Product Change Notice

Issue Date: 6th March 2020

Introduction of new dice sources.

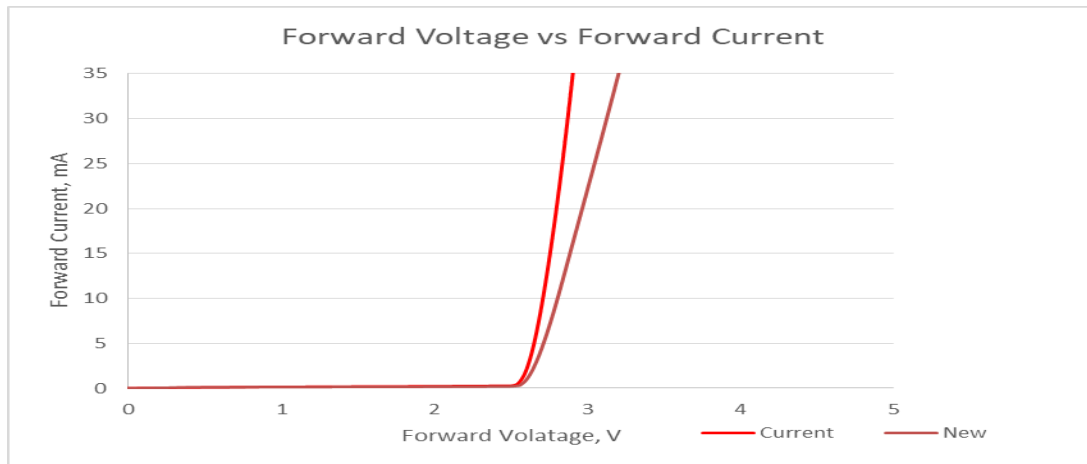
Description and Extent of Change:

Discontinue of current dice supply

There will be no change on fit, form, quality and reliability of final product. Vf characteristic is slightly difference as illustrated below:
